RE: G.V.R.D. RAPID TRANSIT STUDY - LRT ROUTES IN BURNABY

TO: MUNICIPAL MANAGER
FROM: DIRECTOR OF PLANNING
SUBJECT: G.V.R.D. RAPID TRANSIT STUDY - LRT ROUTES IN BURNABY
PLANNING DEPARTMENT
1980 APRIL 08

TO: MUNICIPAL MANAGER PLANNING DEPARTMENT
FROM: DIRECTOR OF PLANNING 1980 February 15
SUBJECT: G.V.R.D. RAPID TRANSIT STUDY - LRT ROUTES IN BURNABY

▲ **fig 1** PRIORITIES FOR LRT CONSTRUCTION

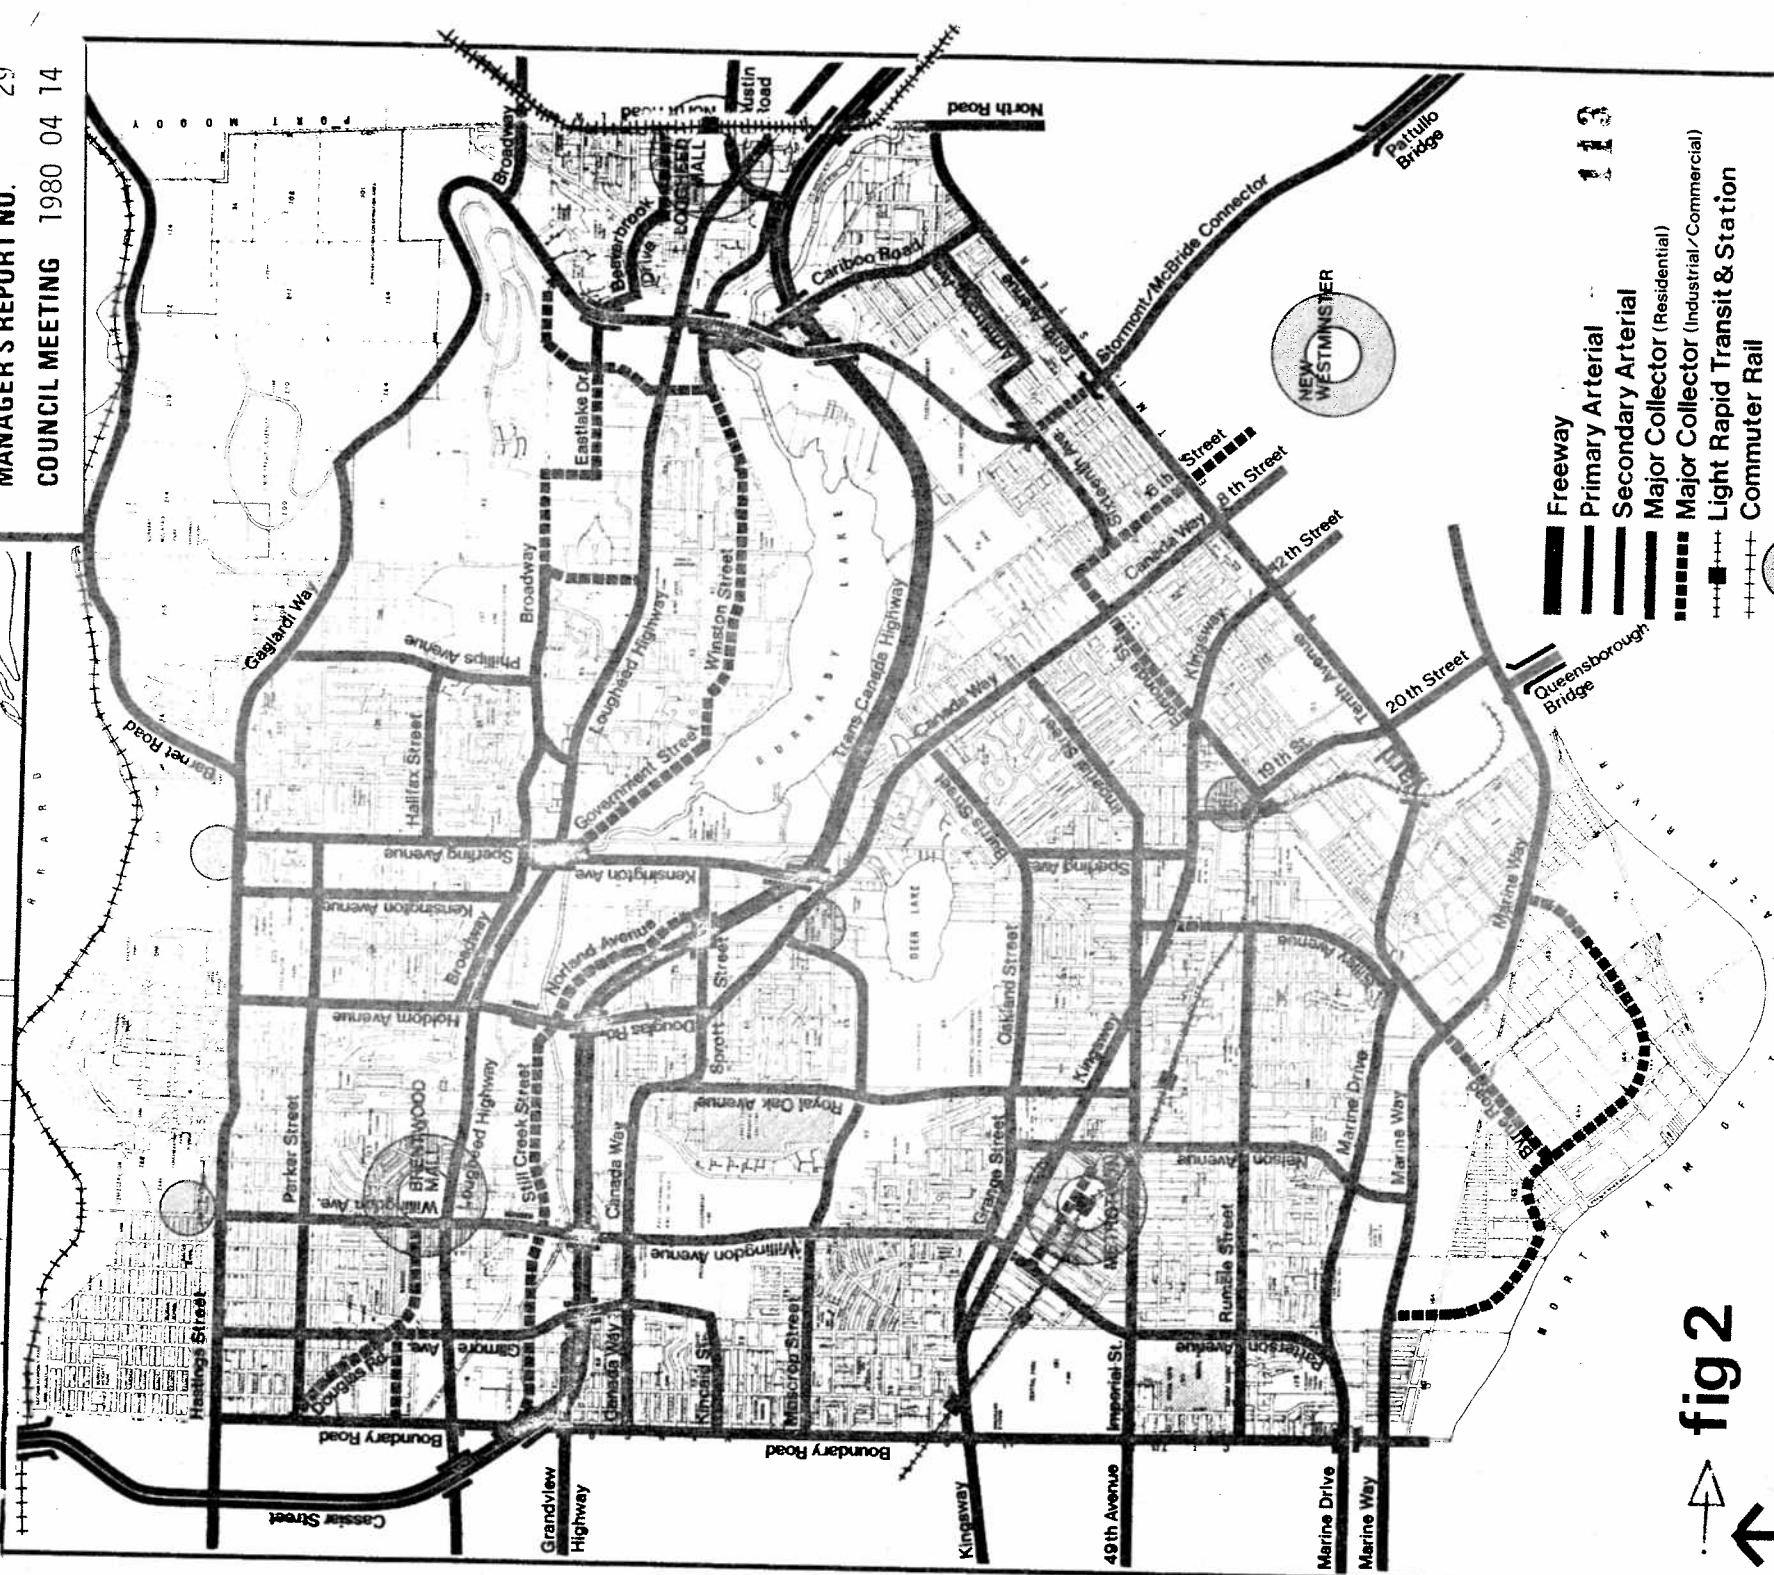
It is proposed that the LRT line from New Westminster to the northeast sector be only extended as far as the Lougheed Mall in the provision of the first priority rapid transit line. The basic alignment utilizes railway rights-of-way to carry it from New Westminster to the Brunette Interchange, where a park and ride station would be provided, and thence to North Road. An alternative alignment which would utilize North Road south of the Freeway was considered, however this alignment would require considerable land-use dislocation and the opportunity for providing a park and ride interchange station that was accessible to the Freeway would be limited. The LRT alignment in Burnaby would be at grade in a central median on North Road from the Freeway to a terminus station at Lougheed Mall.

The primary concern with the preliminary design is related to the at-grade operation of LRT. This requires a signal controlled LRT crossing at the point where LRT makes a transition into the median of North Road (to effect this the LRT has to swing across the northbound lanes) and the LRT would cross Lougheed and Austin at the existing intersections with North Road. The preliminary design proposes that these intersections "be reconstructed to preserve all traffic movements including left turns". However, the North Road/Lougheed intersection and the immediately adjacent major road junctions are heavily congested during peak periods at present and the introduction of LRT into the North Road traffic stream would tend to exacerbate matters. In addition to operational problems there are concerns regarding the safety of effecting a left turn movement across adjacent LRT tracks. Therefore it would appear to be desirable to grade separate the roadway and LRT. The grade on North Road and the expense of subway suggest that an elevated alignment for the LRT is more cost effective particularly because this is a commercial area where an overhead structure would not necessarily be environmentally intrusive. A preliminary examination indicates that approximately 0.8 km (kilometres) of LRT viaduct extending from north of the Freeway to the vicinity of the proposed station is required.

1.2 North Road - The proposed operation of LRT, on surface, along a median strip on North Road is considered to be undesirable due to conflicts with road traffic. Therefore, it is proposed that the preliminary design should specify an elevated alignment between the freeway and the proposed station adjacent to Loughheed Mall.

fig 4

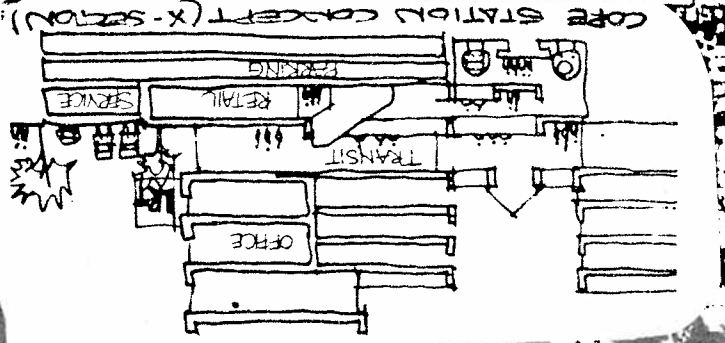
The Vancouver/New Westminster LRT alignment in Burnaby (see Figure 4 attached) makes use of the B.C. Hydro right-of-way for its entire length, except where it deviates to penetrate the Metrotown core. The LRT line is at grade throughout its length except for the subway section at the Metrotown core station and grade separations with the freight railway and Kingsway. Apart from Kingsway and Stride, cross streets are not grade separated from the LRT line and road/rail junctions are signal controlled with priority given to LRT. Noise attenuation barriers have been assumed in the preliminary design.

- 4.4 Central Park Team Track - After undercrossing Kingsway, the LRT line swings south in order to retain a team track loading facility in Central Park that is serviced off Kingsway. Because this necessitates moving a 20" gas main and as the retention of the team track within a park setting is not considered desirable, further effort should be given to the relocation of this facility.

- 4.6 Willingdon - The LRT design does not include consideration of the Willingdon extension through to Patterson which is shown as part of the Metrotown collector network in the Conceptual Transportation Plan. It is expected that with a subway alignment Willingdon would cross over the LRT and intersect the freight railway at a level crossing.

4.9 Nelson/Imperial - The LRT line will cross both Imperial and Nelson at grade at signalized junctions. Municipal staff anticipate a problem with this arrangement because of the proximity of the level crossings to the intersection of Nelson and Imperial. The Rapid Transit project has considered this problem in light of present day traffic but they feel that grade separation would not be warranted. In advance of construction of the LRT line, it would be desirable to further examine traffic flow projections to obviate any possibility of having to provide a grade separation or expensive alterations to the road network a short time after the LRT commences operation. Extension of the Metrotown subway alignment eastward beyond Nelson would alleviate the operational concerns.

1.5 Freight Team Track - The team track facility in Central Park should be relocated elsewhere in advance of the construction of the LRT.

1.7 Willingdon - The relationship of the Willingdon Avenue extension to the LRT line must be defined by a preliminary design. This consideration is related to point 1.1 above.

1.8 Imperial/Nelson - In advance of LRT construction, operational concerns related to proposed grade crossing at Imperial and Nelson in the vicinity of the Nelson/Imperial junction should be resolved. Grade separation by way of extension of the Metrotown underground alignment (see 1.1 above) is a possible means of overcoming these problems.
